Product Change Notification: SYST-25VMMA872

PIC18F06/16Q40 Silicon Errata and Data Sheet Clarifications

Added silicon issue 1.8.1; updated DS revision letter.

1.4.1 UART TXDE Signal May Go Low Before the STOP Bit Has Been Entirely Transmitted

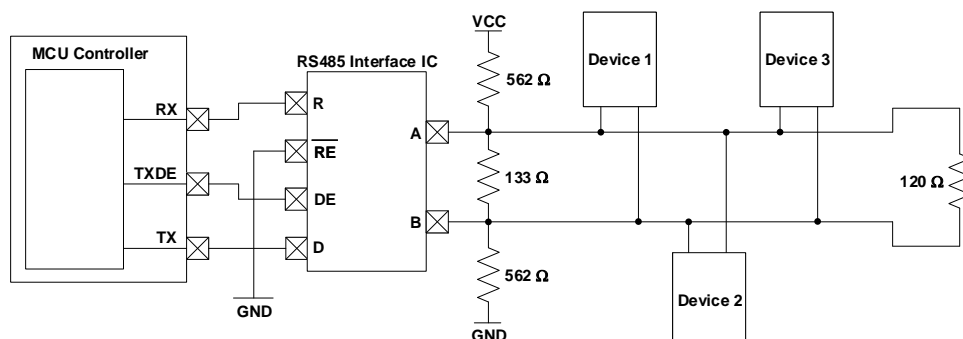
The UART Transmit Drive Enable (TXDE) signal could potentially transition into a low state before the UART STOP bit has been entirely transmitted due to the effects of parasitic capacitance on the TX line. In some applications, this could result in communication being prematurely terminated due to the TXDE signal going low before the STOP bit has had enough time to settle.

To ensure that the STOP bit settles into its final logic state before the TXDE signal transitions low, a biasing circuit can be implemented. A biasing circuit allows the TX line to either be driven high or low, rather than being left in a floating tri-state mode where prolonged rise or fall times could lead

to communication being disrupted. This bias circuit should only be implemented on one end of the serial bus, and a termination resistor should be used on the other end. The figure below shows an example of a bias circuit that can be used to achieve this.

Please note that the resistor values used in this circuit are recommendations and that the actual resistor values required may vary based on the application.
